Modification Recommended Service Note

P5006B Keysight Streamline Vector Network Analyzer

Serial Numbers: From MY61100009 to MY61100135

Potential lifted front panel overlay

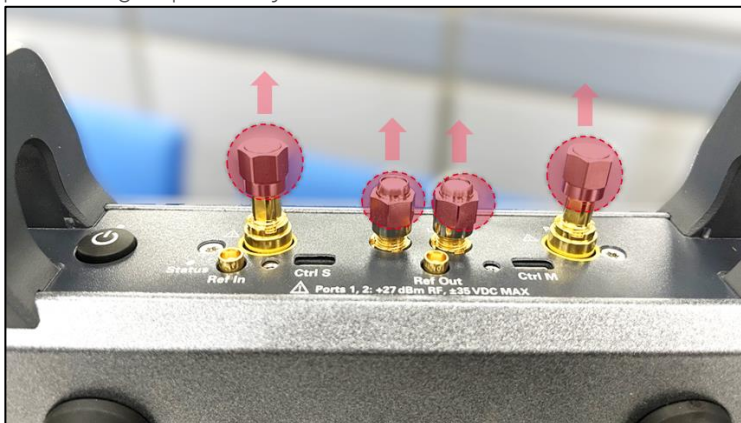
Keysight streamline series vector network analyzer (VNA) of serial number range identified in service note cover page might potentially exhibit the following lifted front panel overlay symptom.

Apart from cosmetic imperfections, the lifted front overlay could have led to non-fully attached *Ctrl S* micro-HDMI cable connector in multi-VNAs setup configuration.

-> Apply this service note only if end users' VNA is exhibiting the following symptom.

Procedure to replace the front panel overlay.

1. Remove the front handles. Detach the 50-ohm termination (LO-In, LO-Out, Port 1 & Port 2) or protecting caps if they are attached to the VNA.

2. Pry open the existing front panel overlay and remove it from front panel.
3. Clean the metal surface thoroughly and ensure it is free of adhesive residue.
4. Affix the new self-adhesive front panel overlay onto the metal surface.
5. Reinstall (reuse) the 50-ohm terminations and port protecting caps accordingly.

6. Reinstall (reuse) the front handles.
